SEWAGE DISPOSAL SYSTEM

SUBDIVISION Forsythe Estates ROAD 14618 Monticello Drive LOT 11A

SAND MOUND
 Plan View

Forsythe Estates Lot-11A
Septic System Design Review

SCALE AS SHOWN APPROVED BY JDC DRAWN BY A.E.S.
DATE: MARCH, 1991
DEBBIE JESTER LOT 11A FORSYTHE ESTATES
MONTICELLO DRIVE HOWARD COUNTY, MD.
SAND MOUND SYSTEM DRAWING NO. 1 OF 1

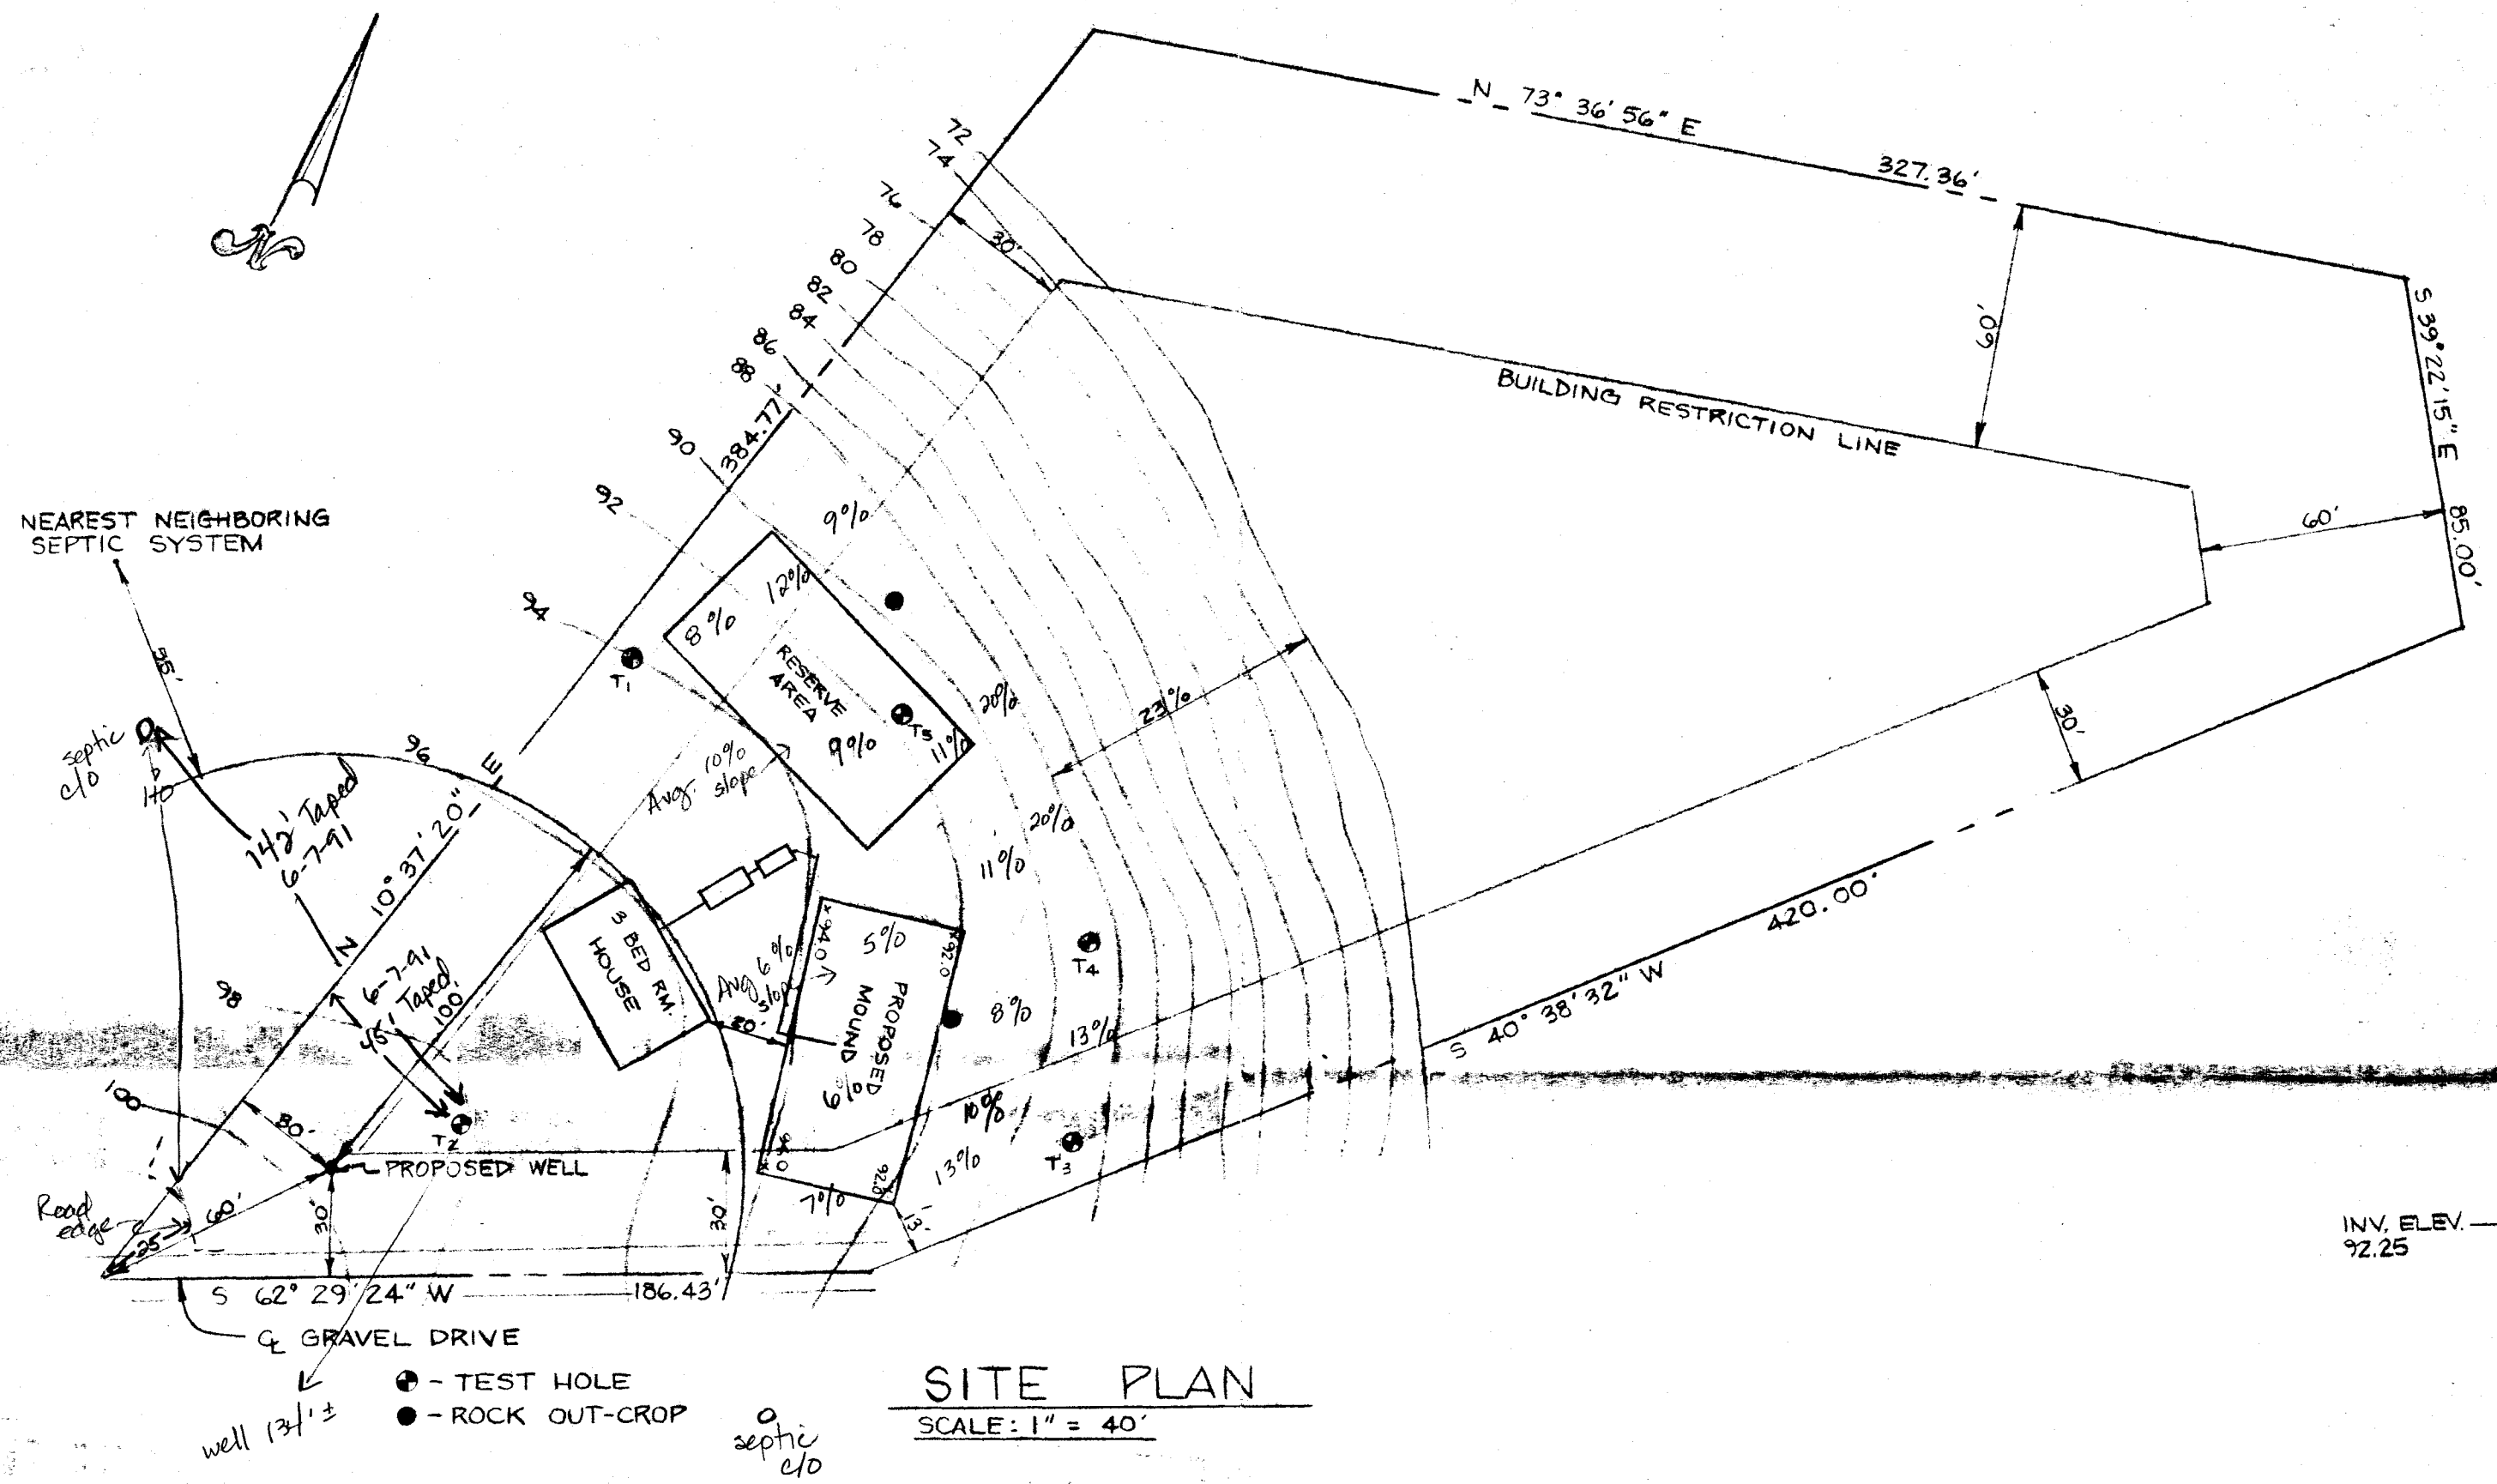
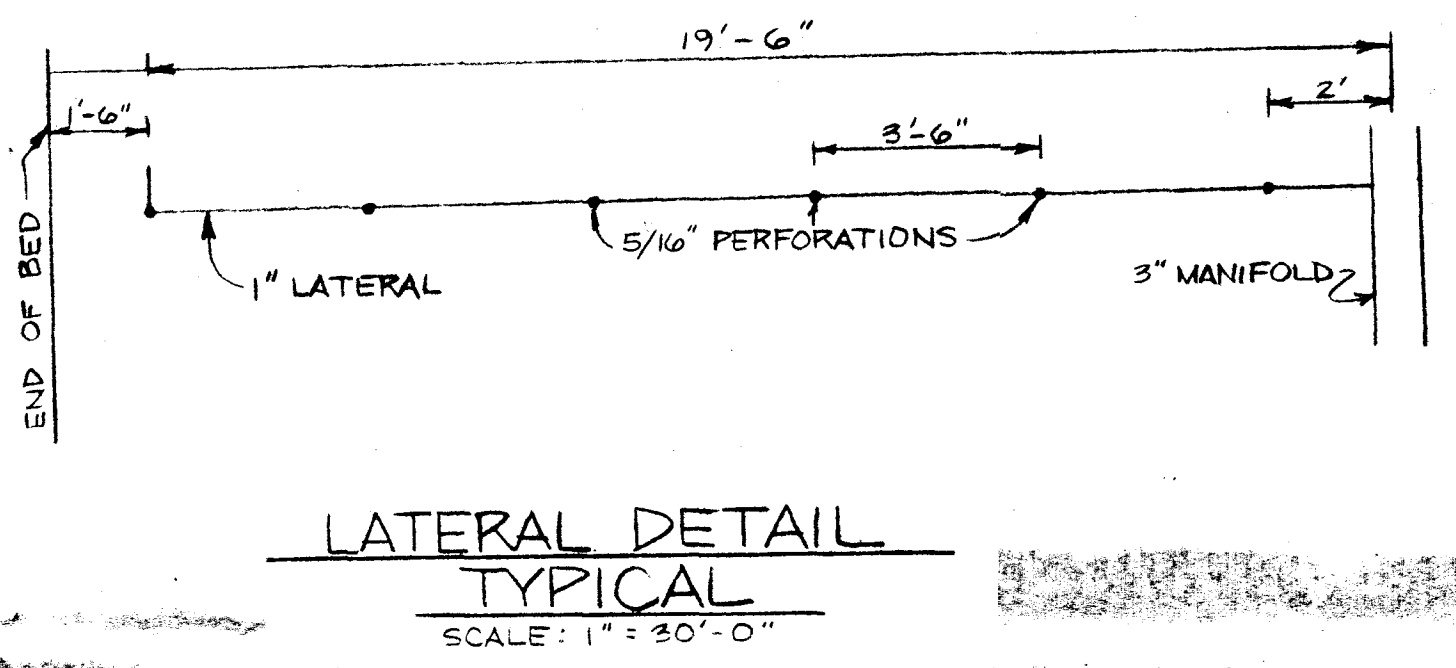
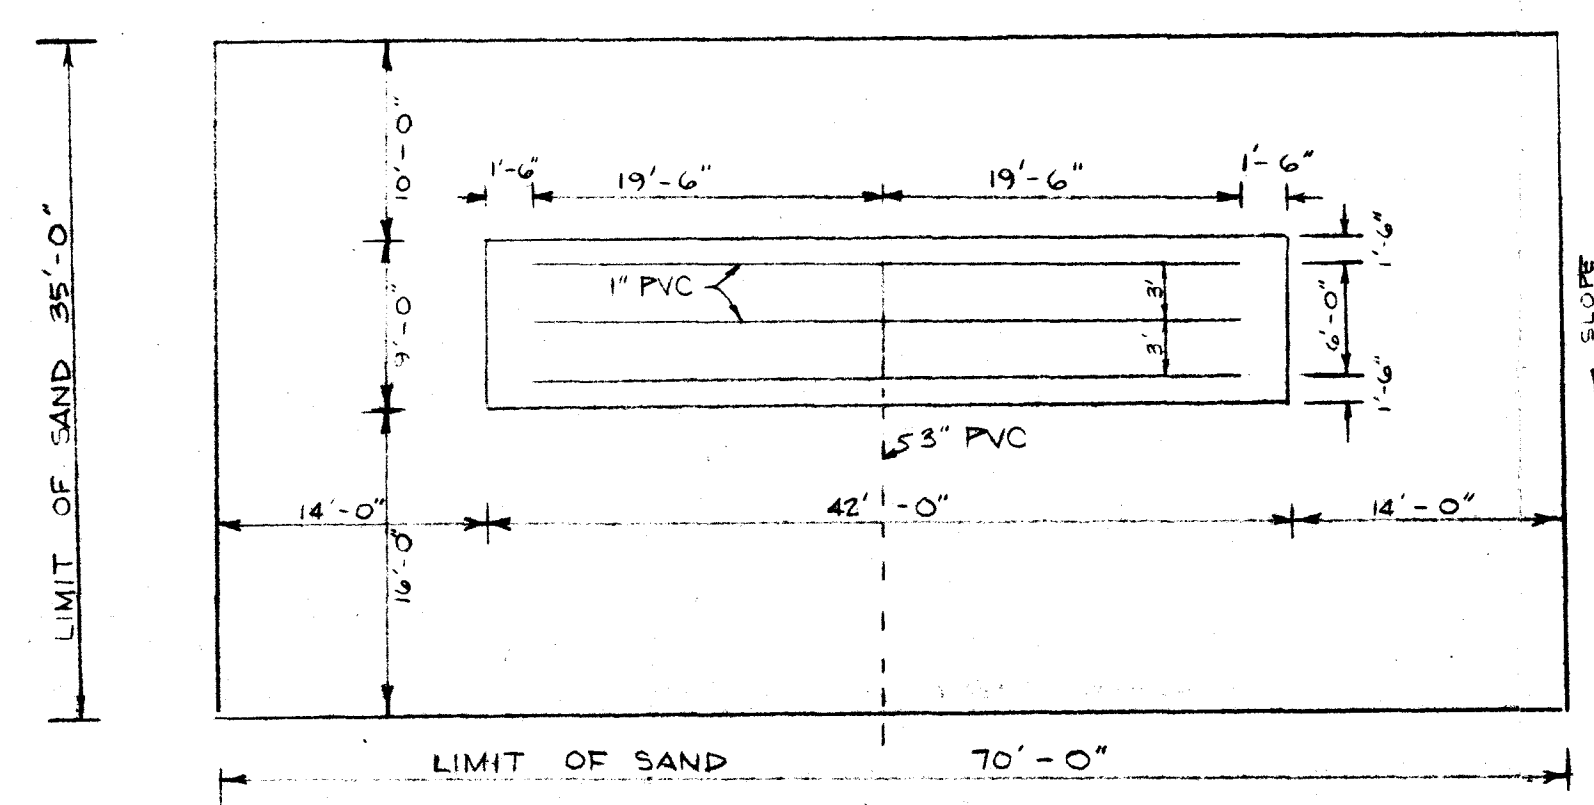
Called Jim Clise re. Forsythe Est. Lot-11A

Need 2% slope 10 ft in front of the tank from the house. Currently 13% drop.

Need statement that all wells & septic within 100 ft of property lines have been shown.

Need to delineate SDA and add note for the standard sewage easement.

Need Health Officer signature block if client wants a signed approval.

? Friction loss at 59 gpm flow (unclear as to how engineer's figures were achieved)

Revised initial SH site 8/6 approved 11/13/92 C. By R.P.

I ADDED THE
NOTE IN THE
SIGNATURE BLOCK
CALL ME IF YOU
HAVE ANY QUESTIONS
